**SSD\_7081: DEVELOPMENT FOR FACULTY OF ARTS & SOCIAL SCIENCES (FASS), CAMPERDOWN CAMPUS**  
**UNIVERSITY OF SYDNEY RESPONSE TO SUBMISSIONS**

**OCTOBER 2016**

The University of Sydney has reviewed all submissions received during the statutory public exhibition period of State Significant Application SSD 7081 – *Faculty of Arts & Social Sciences building*, located on the northern edge of the University's Camperdown campus fronting Parramatta Road, south of campus Science Road, and east of the University's Ross Street entrance.

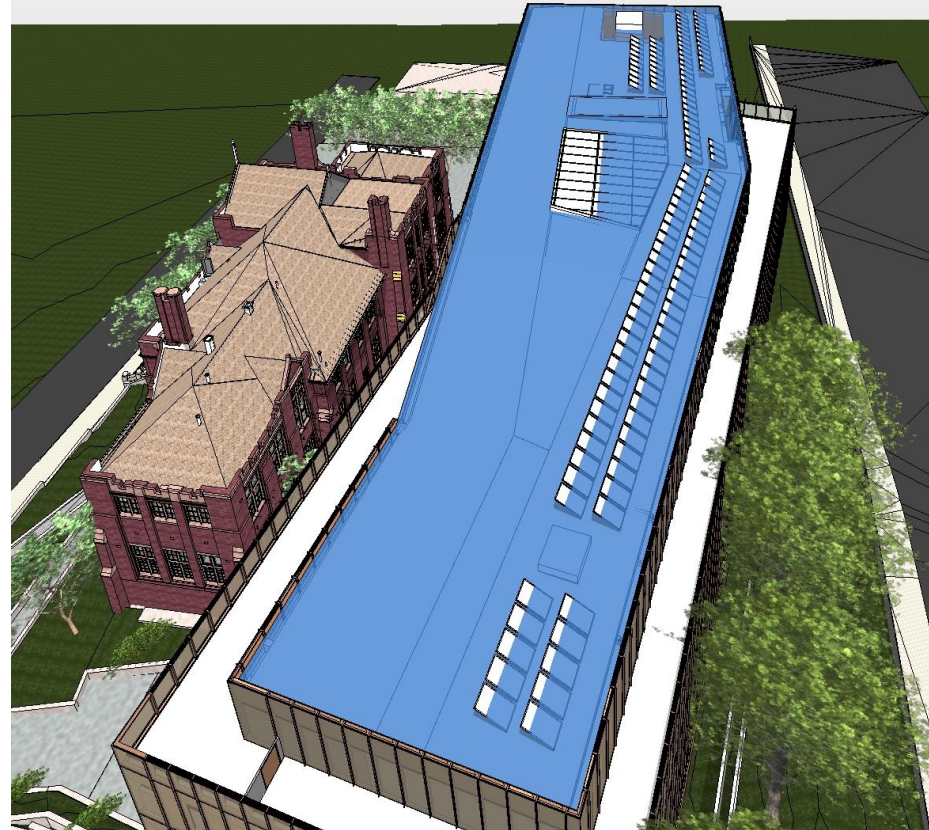
SSD 7081 – FASS BUILDING	
DPE ISSUE	USYD PROJECT RESPONSE
<p><b>Built Form &amp; Urban Design</b></p> <p>1. Given the significant excavation proposed across the site, the Department questions why it is not possible to have designed a building that is fully compliant with the height limit established by the approved CIP building envelope. In this regard, further design refinement should be considered to reduce the height of the proposed building (including plant) to fit within the endorsed RL49.50 CIP envelope height.</p>	<p>As further detailed below, the ground level of the FASS building remains fixed and cannot be lowered or excavated as a result of consequential potential flooding as well as accessibility difficulties.</p> <p>The University has reviewed the FASS building heights against the approved CIP building envelope for this site. The University has now introduced further height reductions to the building comprising:</p> <ul style="list-style-type: none"> <li>Reduction in the level 6 ceiling height to lower the overall roof level by 320mm. This has resulted in reducing the skylight projection through the CIP envelope from 600mm to 280mm.</li> <li>Reduction in skylight area above the CIP from 192m<sup>2</sup> to 37m<sup>2</sup>.</li> </ul> <p>However, the following three elements will protrude above the CIP building envelope and cannot be further reduced. These protrusions are minor, will not cause any negative environmental impact and will not be visible anywhere from the surrounding public domain.</p> <ul style="list-style-type: none"> <li>10m<sup>2</sup> Cooling Tower extending 600mm above the CIP envelope.</li> <li>37m<sup>2</sup> of skylight extending 280mm above the CIP envelope.</li> <li>60m<sup>2</sup> of PV panel area extending 242mm above CIP envelope.</li> </ul> <p>Note, the addition of extra PV panels is in direct response to a recommendation by the City of Sydney.</p> <p>Refer to image below and SK307 illustrating in white colour the minor extent of PV panel, skylight and cooling tower area protruding above the roof area and the CIP building envelope.</p>

Justification for these minor protrusions are substantiated by the following reasons and development constraints:

- A minimum floor to ceiling height of 2700mm needs to be provided to levels 3-6 occupied by academic offices.

SSD 7081 – FASS BUILDING	
DPE ISSUE	USYD PROJECT RESPONSE
	<ul style="list-style-type: none"> <li>• The double height lecture theatre is located at the lower ground floor level 1, therefore setting the floor to ceiling heights for Levels 3 to 6 above.</li> <li>• Level 1 has been set above flood level to allow level access from the South East to avoid building flooding issues from Science Road.</li> <li>• The RD Watt Ground level (Level 2) is fixed. This level dictates the RL of level 2 of FASS to ensure an accessible ground level connection between FASS and RD Watt is maintained.</li> <li>• The roof level is now redesigned by reducing Level 6 floor to ceiling heights from 2900 to 2700mm, and reducing the overall level of skylight from 600mm to 280mm above the CIP envelope. The skylight area is also reduced from 192m<sup>2</sup> to 37m<sup>2</sup> and is set back 6.8m from the facade. Refer to the following Architectus Drawings SK302, 307, DA2500</li> <li>• In relation to the cooling tower (projecting 600mm above the CIP envelope) the University prefers to maintain the water cooled chiller in lieu of air cooled due to a number of environmental advantages being; <ul style="list-style-type: none"> <li>➤ Water cooled chillers require 30% less energy input when compared to an air cooled chiller.</li> <li>➤ Water cooled chillers generate less noise than air cooled chillers.</li> <li>➤ Water cooled chillers typically last longer than air cooled chillers – this has certainly been the experience on campus with 25 years typical for water cooled and only 15 years for air cooled chillers – this leads to a reduced embodied energy cost.</li> </ul> </li> <li>• The most compact water cooled chiller has been selected which has specific dimensional requirements that cannot be reduced below the CIP envelope. Therefore the University wishes to retain the water cooled chiller and associated cooling tower plant due to the reduced energy and embodied energy advantages.</li> </ul>

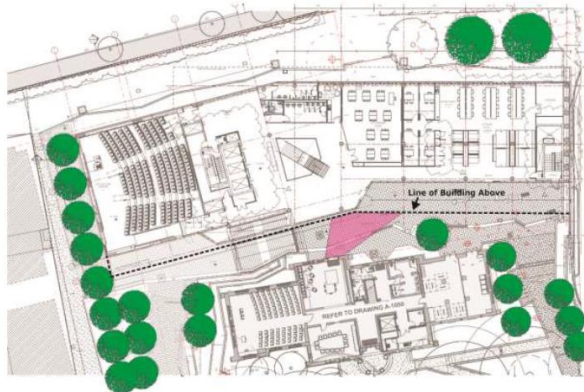
3. That a <b>wind tunnel study</b> is conducted to quantify the wind effects of the proposal.	In response to this request Windtech has reviewed the updated landscape design and has determined that unusual wind patterns that would require more detailed wind tunnel testing is not expected for this project due to the extensive shielding of the subject development and relatively low rise form.

SSD 7081 – FASS BUILDING	
OGA RECOMMENDATIONS	USYD PROJECT RESPONSE
	<p>Windtech concluded that the inclusion of the additional tree planting along the western boundary of the site, and the western and eastern aspects of RD Watt will be effective in baffling any approaching winds to the forecourt area of the subject development. Furthermore, this layout will assist in helping to stagnate any down-washed southerly winds. The effect of down-washed winds off the southern façade to the forecourt below will be minimal given the height of the proposed development with respect to the RD Watt Building roof.</p> <p>The Windtech report (Appendix 1.05) acknowledges the amended Landscape Plan which includes a considerable amount of additional tree planting along the western aspect of the site to mitigate potential wind effects (plan extract report below from Windtech report).</p> <div data-bbox="1263 777 1845 1315"> <p><b>Recommended Treatments</b></p> <ul style="list-style-type: none"> <li> Densely foliating evergreen trees capable of growing to a height of 4m with a 4m wide canopy recommended to be included.</li> <li> Impermeable awning recommended to be retained.</li> </ul>  </div> <p>Figure 3b: Landscape Design with Recommended Treatments – Ground Level</p>

Figure 1: Pedestrian Desire Lines

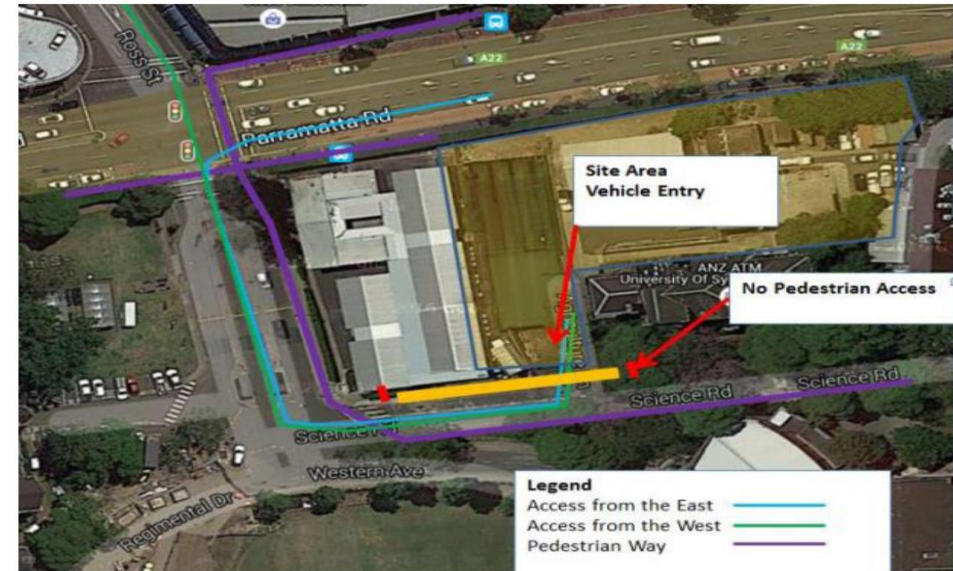
SSD 7081 – FASS BUILDING													
TfNSW ISSUE	USYD PROJECT RESPONSE												
<p>1. Concern with construction vehicles accessing the site via Parramatta Road at Ross Street in the lane utilised by all Parramatta Road bus services. It is noted there is a bus stop positioned 27m from the intersection where these construction vehicles will be turning into the site.</p> <p>Construction vehicles will have to merge into the bus lane, before the intersection so they can turn into the site. This may have an impact on bus operations in the corridor which is not adequately addressed in the TAIA or the Construction Management Plan (CMP).</p> <p>Therefore it is recommended that an addendum to the TAIA is developed as part of the response to submissions that addresses the following additional criteria:</p> <ul style="list-style-type: none"><li>• Cumulative impacts associated with other construction activities;</li><li>• Anticipated peak hour and daily truck movements to and from the site anticipating that peak movement times for students will be avoided;</li><li>• A detailed assessment of how traffic and transport impacts during construction will be mitigated for any associated traffic, pedestrians, cyclists and public transport operations.</li></ul>	<p>GTA has reviewed this comment and provided a complete response within Appendix 1.06. A summary of their comments are as follows:</p> <p>The FASS project will occur in line with the following campus projects:</p> <ul style="list-style-type: none"><li>• F23 Administrative Building (F23)</li><li>• Lees 1 Building (Lees)</li></ul> <p>The construction of FASS is scheduled to occur between November 2016 and May 2018 (i.e. 15 months) while those of F23 and LEES1 are expected to commence in December 2016 and have an expected completion date of May 2018, i.e. 18 months.</p> <p>Comprehensive Construction and Traffic Management Plans (CTMP) have been prepared for all three projects and indicate the following construction traffic frequencies:</p> <p>Table 1: Construction traffic movements by projects</p>

SSD 7081 – FASS BUILDING	
TfNSW ISSUE	USYD PROJECT RESPONSE
	<p>The FASS CTMP indicates that the site will be accessed primarily from the west via Ross Street and from the north and east via Parramatta Road. The CTMP's for F23 and LEES1 each indicated that their site accesses are provided via City Road and are therefore independent of the intersection at question.</p> <p>Based on the above, some 75% of the FASS construction access movements is anticipated to involve the Parramatta Road and Ross Street intersection, i.e. some 11 vpd during the excavation phase and subsequently 15 vpd during construction period with occasional concrete pours being up to some 30 vpd.</p> <p>Based on the approved daily construction duration of 11 hours (i.e. 7am to 6pm), expressing the above traffic generation on an hourly basis would indicate the following projections:</p> <ul style="list-style-type: none"> <li>• 1 vehicle per hour (vph) during the excavation phase</li> <li>• 1-2 vph during the construction phase</li> <li>• 3 vph during peak concrete pours.</li> </ul> <p>A review of the Transport NSW database reveals that the bus stop (westbound direction) situated east of the subject intersection accommodates some 50 bus services during the peak periods (i.e. 7am-9am and 4pm-6pm). On this basis, the construction traffic represents some 4% of the peak hourly bus movements while during peak concrete pours, 6%. It is considered that although a truck would 'straddle' between two lanes during its entry manoeuvre to the site, the frequency at which it occurs is not anticipated to be averse to existing bus operation.</p> <p>The CTMP also identifies the existing pedestrian desire lines surrounding the site (Figure 1 overleaf).</p>

Traffic consultants GTA conclude that the CTMP has appropriately addressed the safety of pedestrians by introducing a 'No Pedestrian Access' zone in front of the site. However, it is considered that this can be further enhanced by appointing accredited traffic controllers at the Science Road marked pedestrian crossings, in particular during the university term, to provide additional protection to students travelling between Ross Street and Western Avenue. In addition, water-filled barriers may be appointed at the boundaries of trucks' travel path to provide physical deterrence to students/pedestrians from interfering with truck movements/activities.
